**Sandia National Laboratories
Albuquerque, New Mexico
December 19, 2003**

**Environmental Restoration Project
Responses to New Mexico Environment Department
NOTICE OF DEFICIENCY**

**for the
Mixed Waste Landfill: Corrective Measures Study Report, May 2003
EPA ID#: 5890110518
HWB-SNL-01-025**

Figure 3-2 Complete Excavation with Aboveground Retrievable Storage and Backfilling

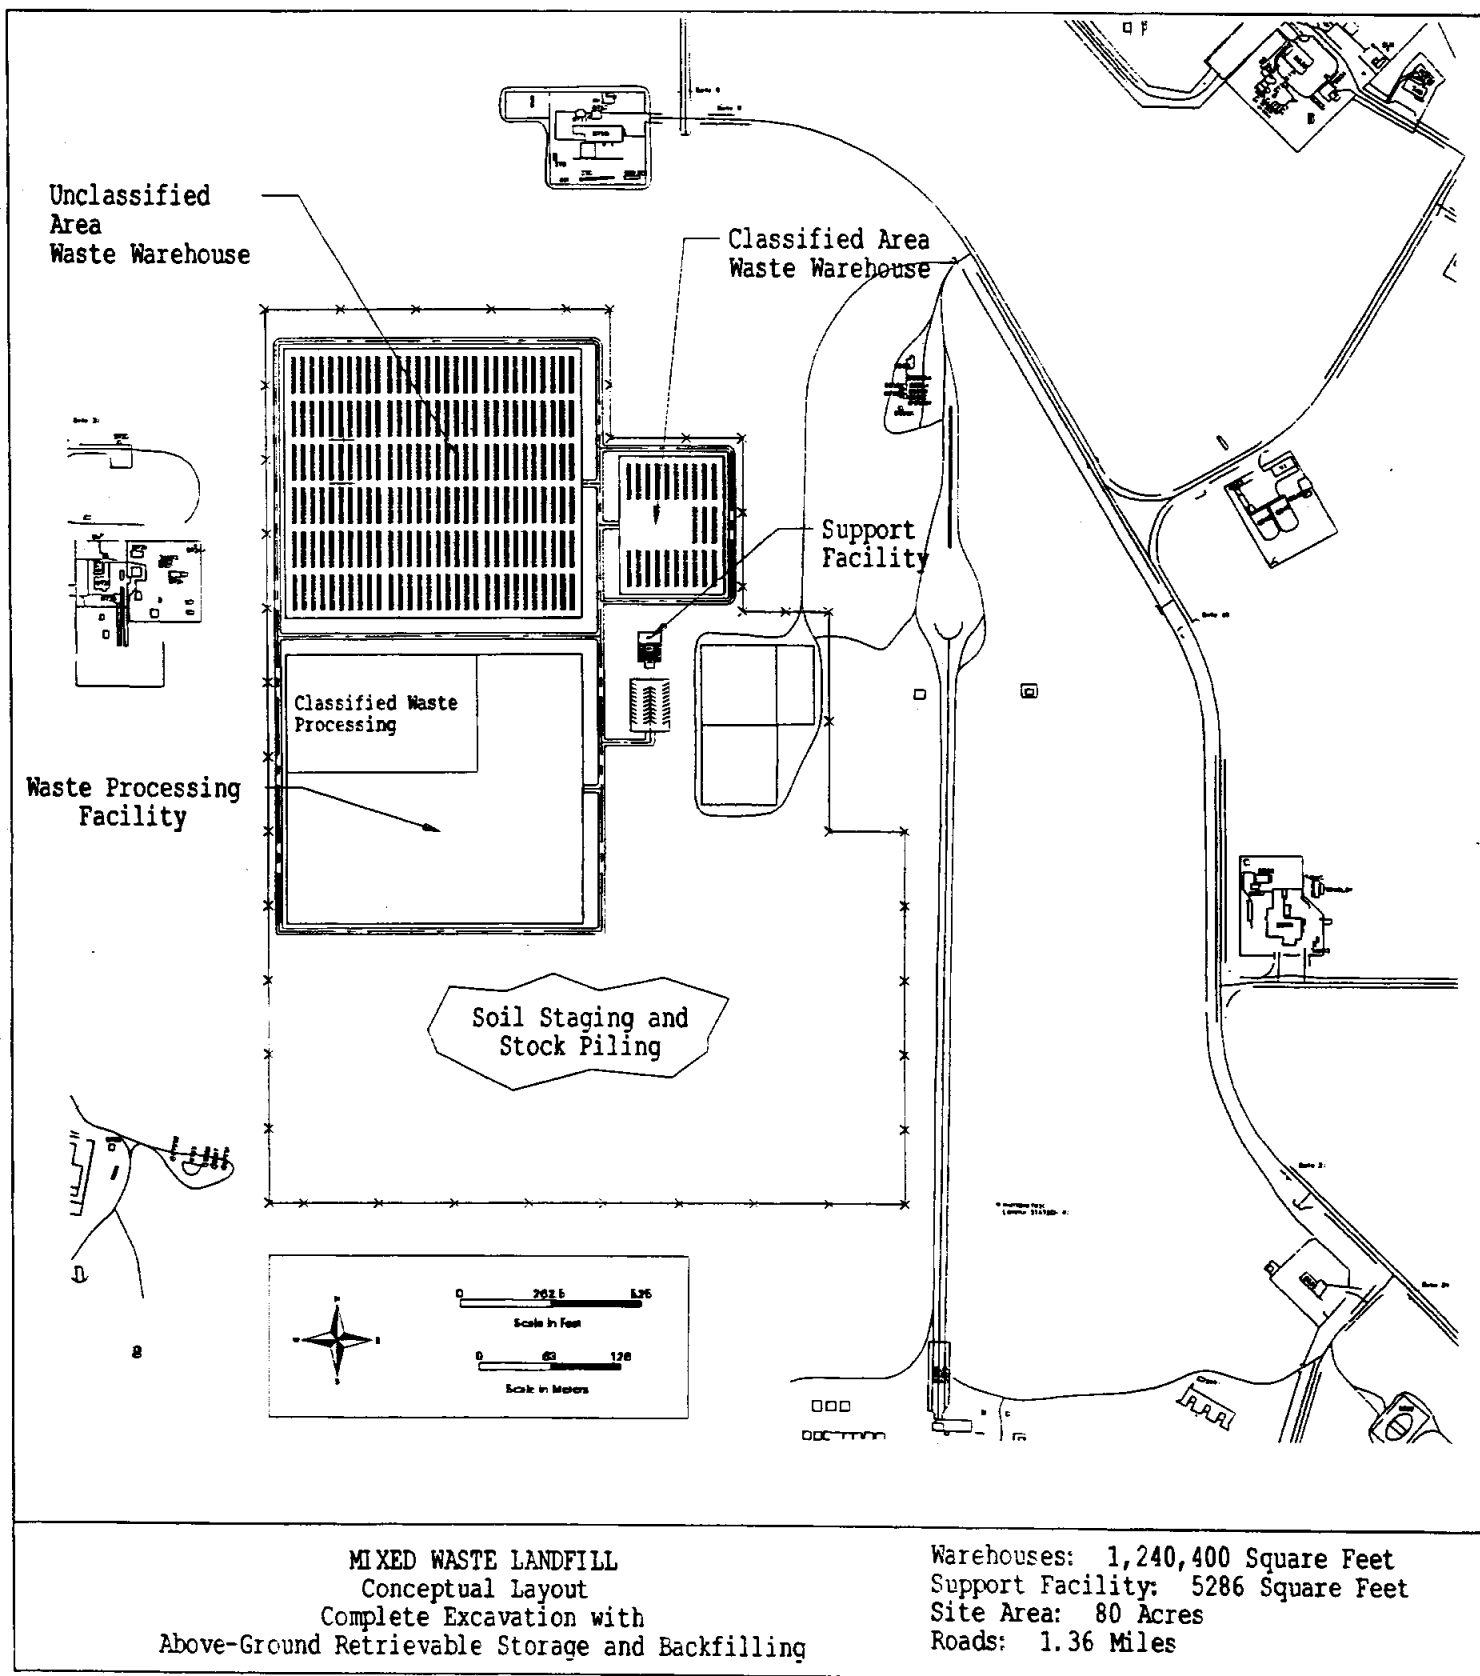
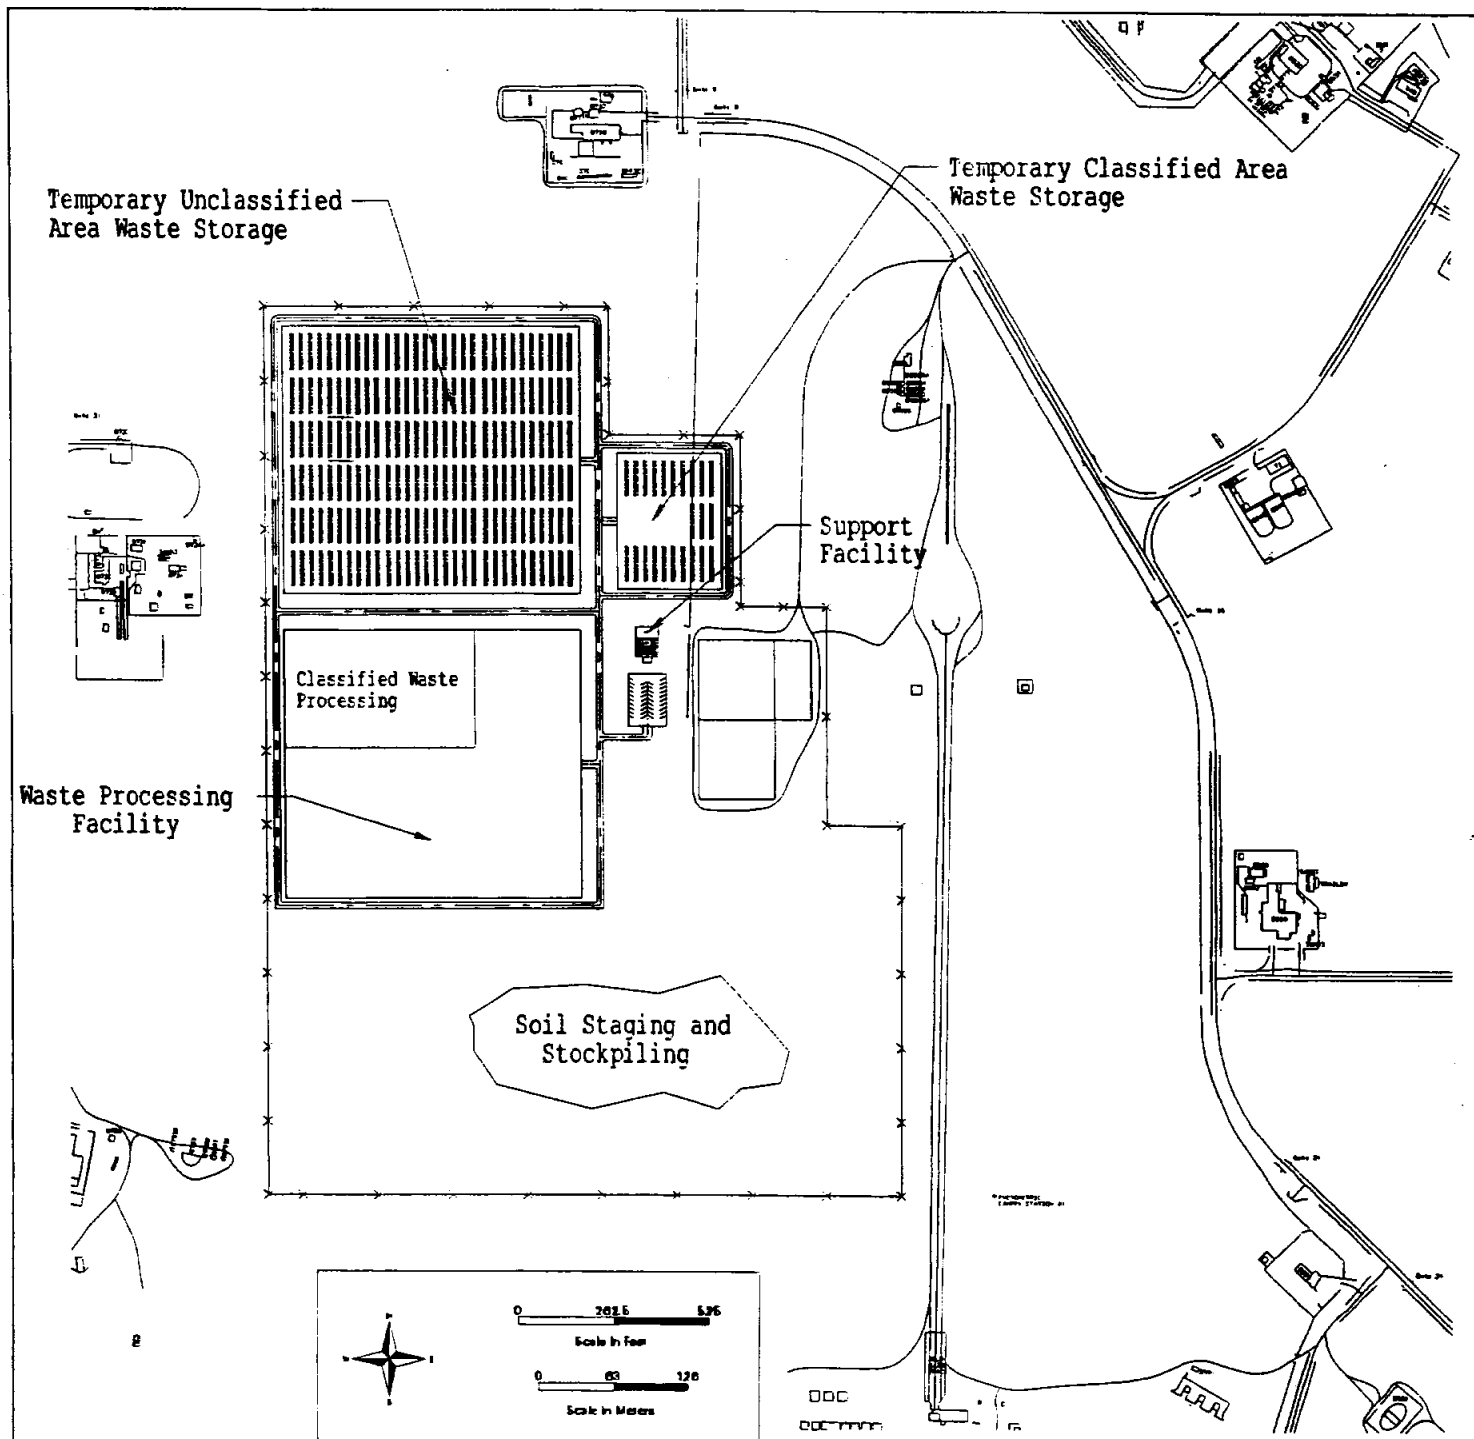
11. Figures 3-1 through 3-7. All of these figures do not include a scale. Resubmit the figures with the appropriate scales included. The addition of an arrow to indicate the north direction on each figure should also be included for the benefit of the public.

DOE/SNL Response: An appropriate scale and a north arrow will be added to Figures 3-1 through 3-7. The revised figures are included in Attachment A.
